First Addendum to the Environment Impact Assessment for Koodoo Domestic Airport Extension and Development of Airport Hotel at Koodoo island, G.A. atoll

Prepared for
Keong Hong Construction Pvt. Ltd.

Subject: 1st Addendum to the EIA Report for Kooddoo Domestic Airport Extension and Development of an Airport Hotel at Kooddoo, Ga. Atoll

Figure 3: Revised concept plan of Kooddoo Airport Hotel approved by Ministry of Tourism

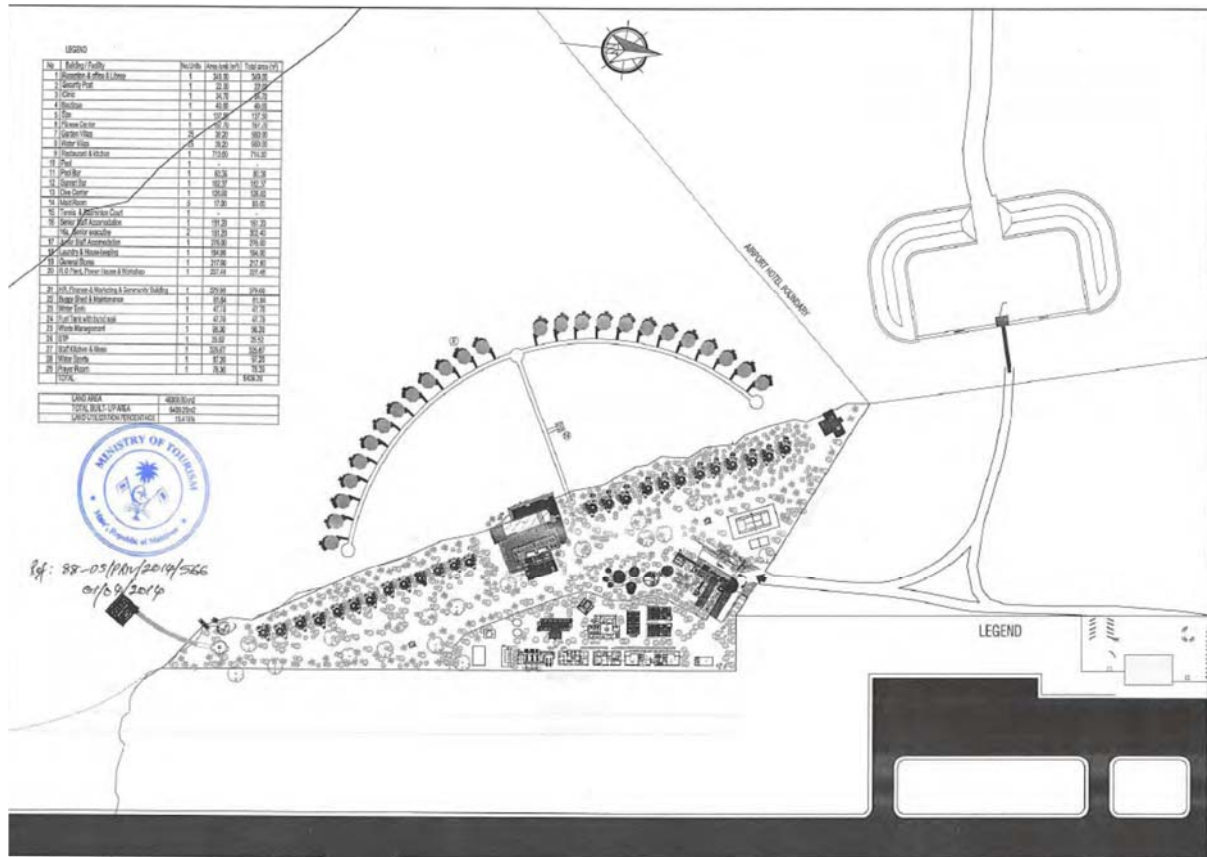
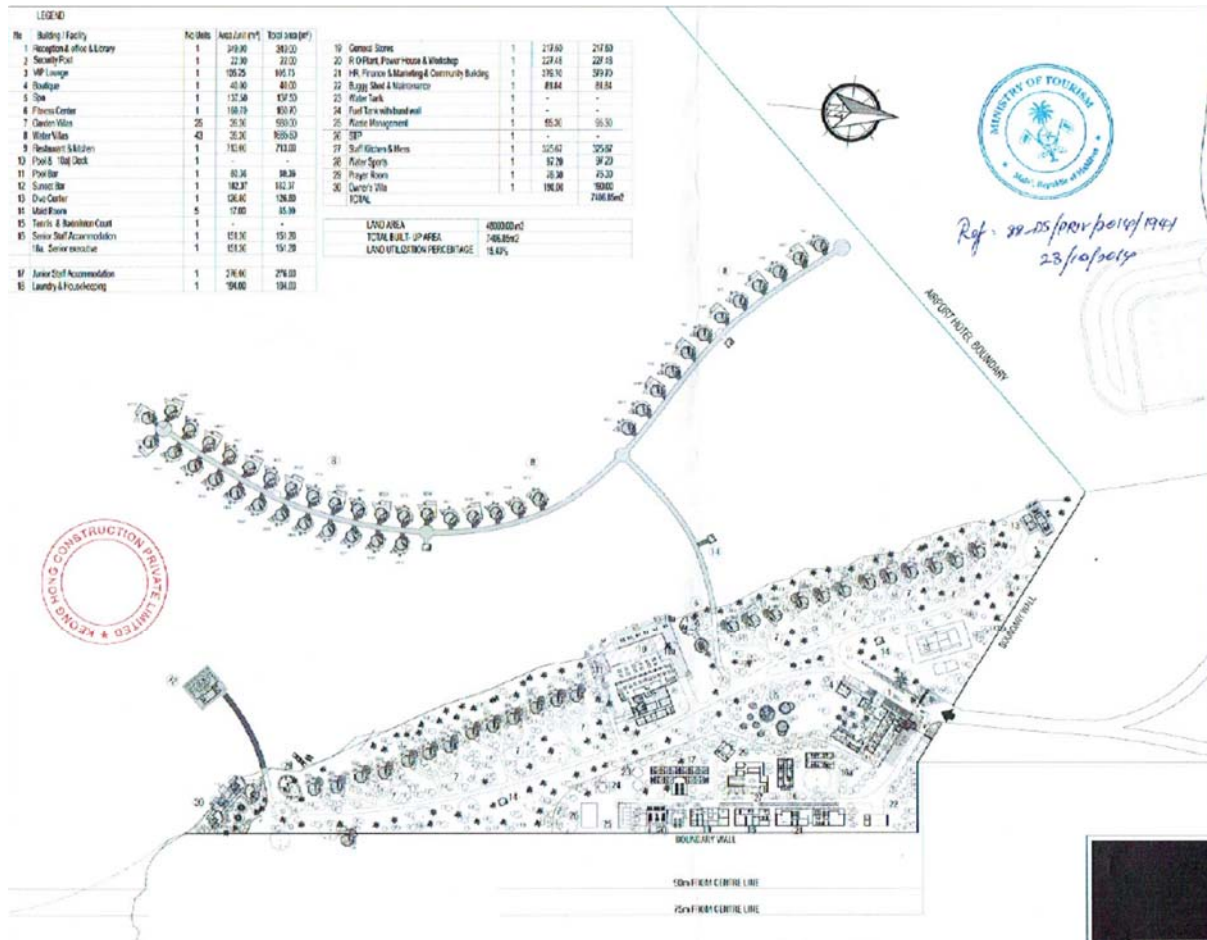
The proposed changes to initial concept of Kooddoo Airport Hotel are shown in *Table I*. *Figure 2* and *Figure 3* are presented to illustrate the changes to the concept plan. The revised changes to the proposed concept plan of the Airport Hotel includes the following:

Water villas were previously arranged in a single side of a semicircular shape over hanging walkway on the western lagoon of Kooddoo Island. The new arrangement of the water villas take the shape of an arc and positioned almost on the same location of the semicircular walkway designed in the earlier concept plan. Water villas are arranged on both sides of the southern part of the arc-shape over hanging walkway. With this change a single row of water villas be arranged in northern arm of the arc while a double row on southern arm of the arc shape over hanging walkway in the lagoon.

Initially it was proposed to have 25 garden villas and 25 water villas at the Kooddoo Airport Hotel. With the revision brought to the concept 18 water villas were added and the number of villas increased from 25-43. With this change the total number of the rooms in Kooddoo Airport Hotel will increase to 68 rooms.

Additional accommodation room will be developed specially for the owner of the hotel. The room is located on the southern end of the island next to the sunset bar. Total area allocated the owners villa is 190m²
